Lead Local Flood Authority

Date 19th February 2026

RE: DM/25/3129– Land At Borde Hill Lane, Haywards Heath, West Sussex

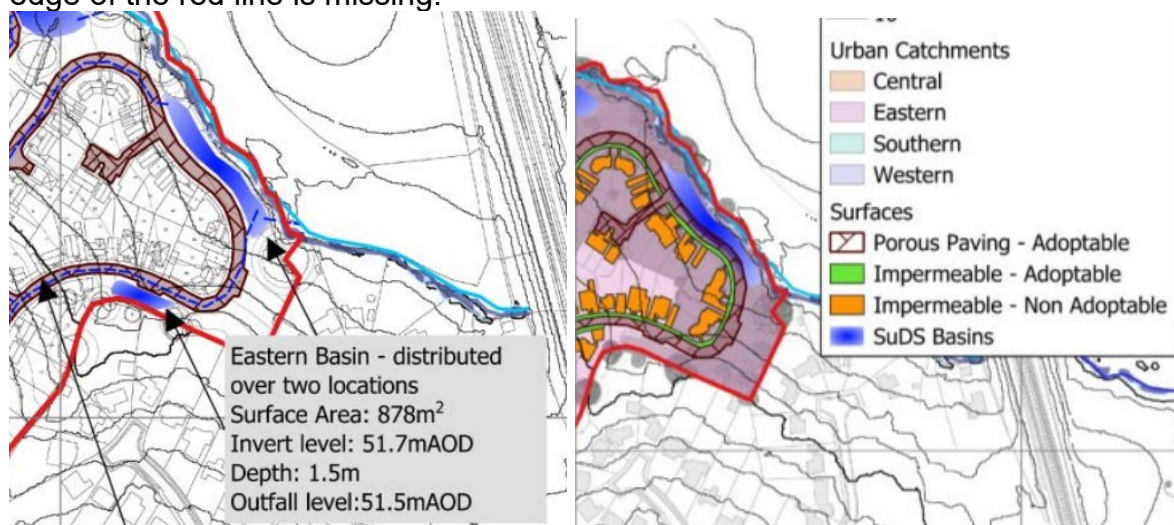
1. We have concerns that the layout shows there are houses located within a surface water flow path, which is clear evidence that the applicant has not followed a sequential approach, as highlighted by Figure 4-3 in the Flood Risk Assessment. As stated in PPG Flood Risk and Coastal Change, development in current and future medium and high surface water flood risk areas should be avoided, prior to considering mitigation measures. This is because avoidance is the most effective way of managing surface water flood risk.

While mitigation has been mentioned in 6.2 of the FRA, we require additional information. The current mitigation for the main surface water flow path through the site includes using additional gullies within the road network. Although not clearly explained, it is though the applicant proposes that the flow path would then be intercepted. We are unconvinced that such an approach is appropriate.

We have concerns that these proposals will not adequately mitigate the surface water flood risk. A gully is designed to accommodate a smaller rainfall event compared to the design event for a sustainable drainage system. This could mean

that the proposals are ineffective in ensuring the entirety of the flow in the surface water flow path are intercepted and surface flows may not be able to be captured and conveyed into the drainage network beneath the highway fast enough. In addition, the road network that it is proposed to be used for mitigation is connected to the northern basin, which is located in a different natural catchment to the existing surface water flood risk. It is unclear what would occur if the highway drainage was not correctly maintained, as the surface water flow path would naturally flow downhill towards the watercourse, through an area where the applicant now proposes to situate houses. This could increase surface water flood risk elsewhere.
